## Saltash Community Space

### Preliminary Report

*24092-CSL-GEN-Saltash Community Space-DE-D-0001-Feasibility Report*

### Safety Review

Infra24-092-CSL-HGN-SX428588-DE-D-0001-P01

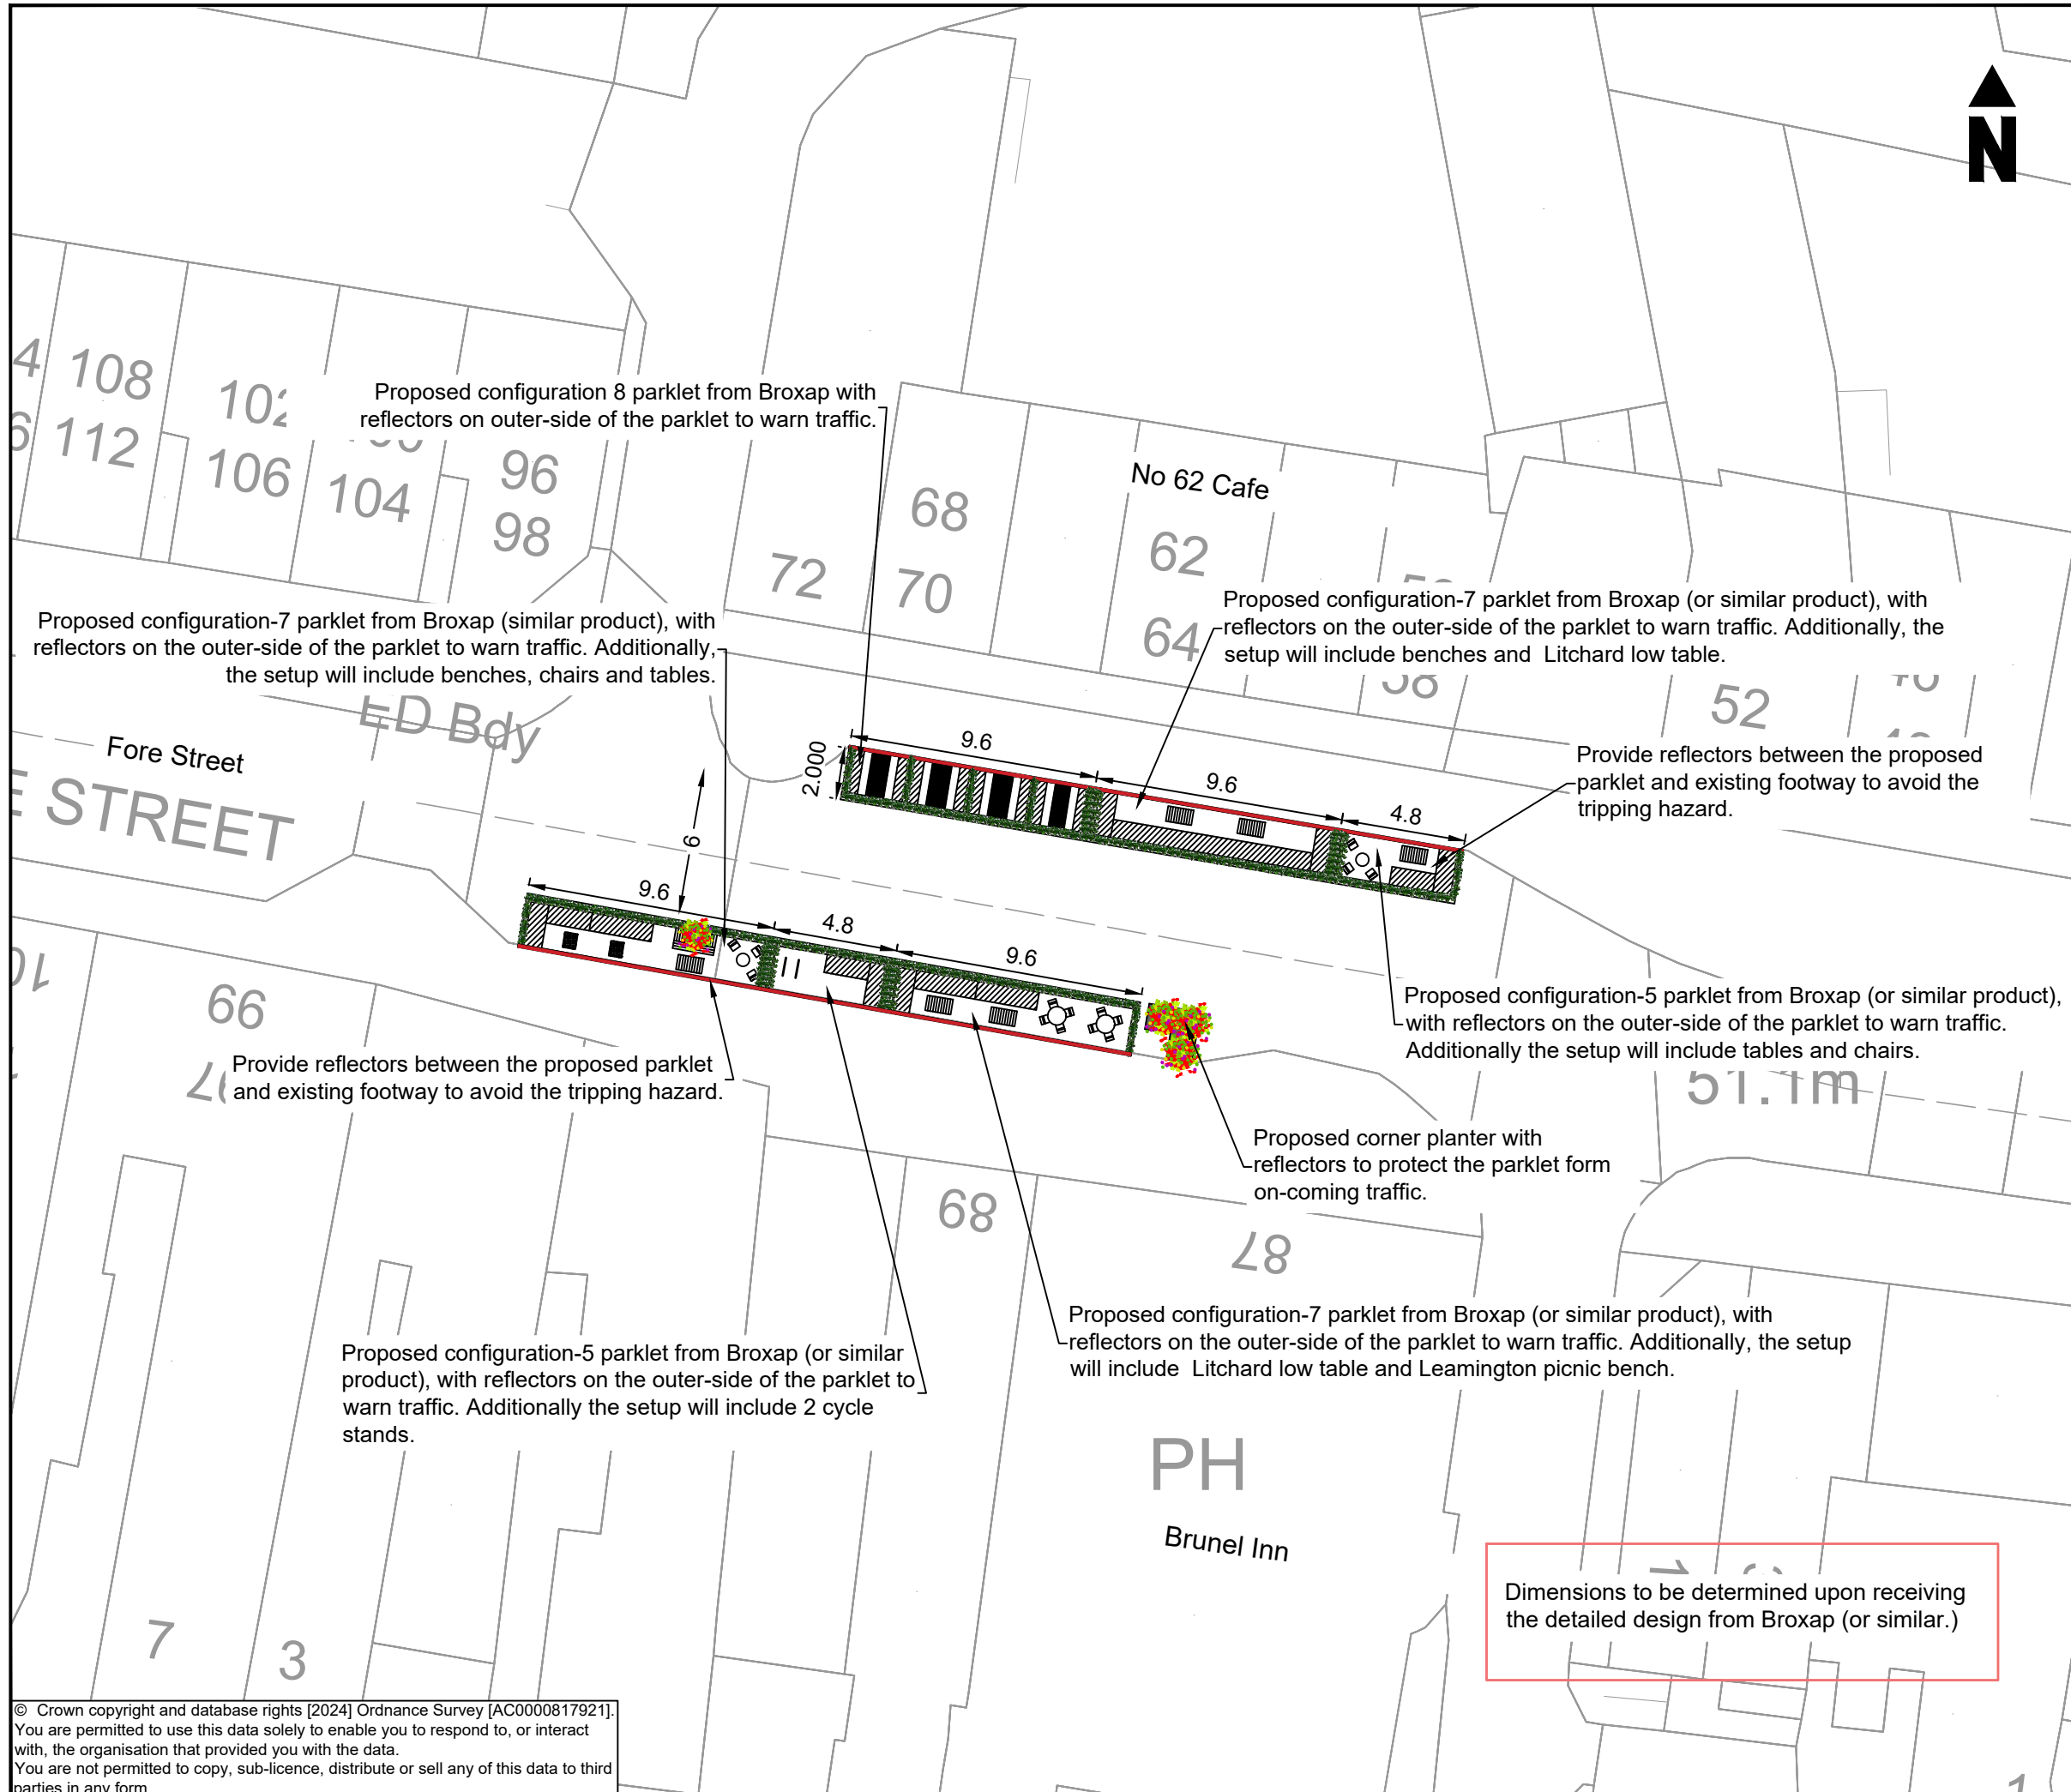
2.1.4 A Road Safety Review has been undertaken by the road safety team on the principle of providing parklets at this location (Appendix B). The review has been undertaken based on the concept design previously produced for the town council. The recommendations have been considered for the layout shown in Appendix A as follows:

- 4i- The review recommended that an adequate footway width of at least 2m be maintained. All the parklet options given above have options that fit within the parking bays without encroaching on the footway (since the parking bay is 2.1m wide), therefore this safety recommendation can be addressed.
- 4ii- The review recommended parklets should not be installed in a way that encroaches on the carriageway. As noted above, the proposed parklet options all fit within the parking bays and therefore do not encroach on the carriageway.
- 4iii- Comments were made around the level differences at the parklet access and the potential for trip hazards on the footway. Given the gradient issue, it may be desirable to include ramps to ensure accessibility:

The review recommended planters or bollards are provided adjacent to the ramps to prevent tripping hazards if such is implemented. Alternatively, a step up onto the parklets could be left, provided that a reflective strip is installed on the step (as depicted in the drawing in Appendix A).

- 4iv- The review raised the potential risk of users falling over the rear of the parklets if adequate barriers are not provided. The parklet options

investigated all appear to include options to provide high-sided barriers on the carriageway side, either using planters or balustrade railing, which appear sufficient to address this risk.

- 4v- The review raised the potential risk of pedestrians colliding with each other if high-sided planters abut the footway. Similar to the above, all the parklet options have a degree of modularity, which should allow selection of low-sided planters to mitigate this risk. It is recommended low-level planting species are also provided on the sides of the parklets.
- 4vi- The review recommended reflective markers are provided on traffic facing corners of the parklets to guide drivers past. This can be incorporated into the design relatively easily, with reflective tape being an option.
- 4vii- The review recommended parklets not be positioned in way that impede drainage gullies. All the options appear to include bases that are adjustable to some degree, which would allow flow of surface water beneath them.

In summary, parklet products are available that would address the recommendations raised in the road safety review. It is recommended these issues continue to be reviewed when selecting the final parklet product.
